Evaluation of Physical Barriers- Moreno Valley / March Field Station

Address: 14160 Meridian Pkwy, Riverside, CA 92518

Evaluation Date: 08-05-2021

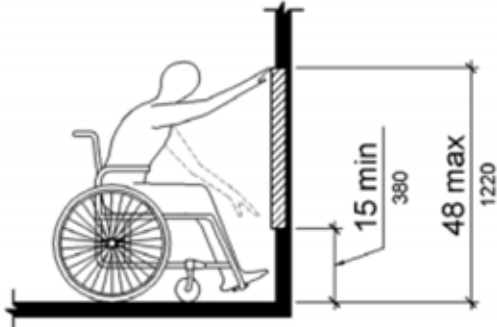
| Issues | Recommendations | Comments |
|--|-------------------------|--|
| <p>1. Curb Ramps</p> <p>1a, 1c - OK 1b -Trip hazard due to level change in Detectable Warning Surface (DWS) tile 2a- Trip hazard due to level change in DWS. 2b, 2c – OK 3a - Trip hazards due to level change in DWS. Level change at the concrete base needs maintenance. Cross slope of curved ramp may exceed 2%. 4a, 4b-OK 5a, 5B – Not on an accessible route yet. No issues found.</p> <p>Need to verify slope of the gutters at all curb ramps adjoining gutters with properly sized instrument</p> <div>   </div> <div>  </div> | <p>See Item 3 below</p> | <div>  <p>Figure 406.2 Counter Slope of Surfaces Adjacent to Curb Ramps</p> </div> <p>This evaluation does not include curb ramps outside the RCTC boundary. RCTC is not responsible for maintaining the accessible routes outside of RCTC boundary.</p> <p>When repairs begin, use proper and precise instruments (4-foot smart level and 2-foot smart level) to fit within the curb ramp width and the adjacent gutter to measure ramp slopes, cross slopes, and counter slopes at all curb ramps (all stations). The long slope of ramp shall not exceed 1:12 (8.33%). Slope of flared sides shall not exceed 1:10 (10%), the gutter slope shall not exceed 1:20 (5%). Cross slope of the ramp and landing shall not exceed 1:50 (2%)</p> <p>Use smart level instruments, calibrated in accordance with manufacturer’s instructions before taking measurements.</p> |

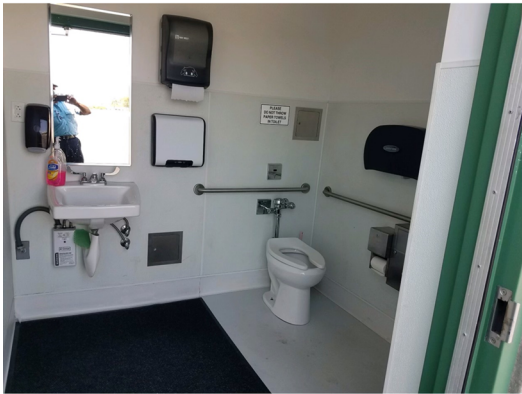
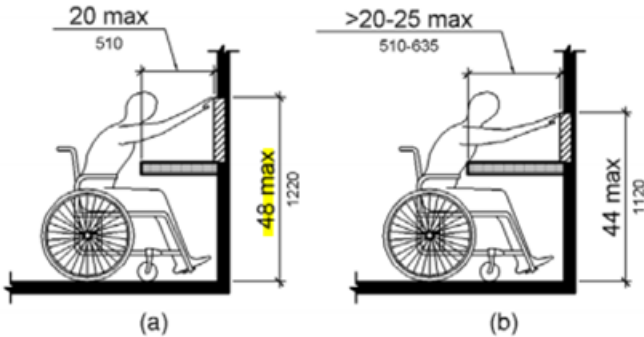
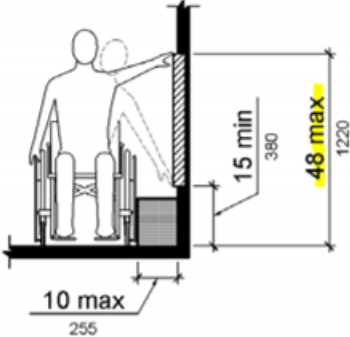
| Issues | Recommendations | Comments |
|--|---|---|
| <p>General: Joints and gaps in concrete to be repaired or maintained for compliance with 302.3, 303.2, and 303.3.</p>  | <p>Examine all pedestrian routes and repair all cracks.</p> <p>Every joint in concrete deeper than ¼" and wider than ½" shall be filled.</p> <p>Every level change along the accessible route greater than ¼" and less than ½" height needs to be beveled (1:2) slope or repaired.</p> <p>Every level change greater than ½" needs to have a ramped surface (1:12) slope.</p> |  <p>Figure 302.3 Elongated Openings in Floor or Ground Surfaces</p>  <p>Figure 303.3 Beveled Change in Level</p>  <p>Figure 303.2 Vertical Change in Level</p> |
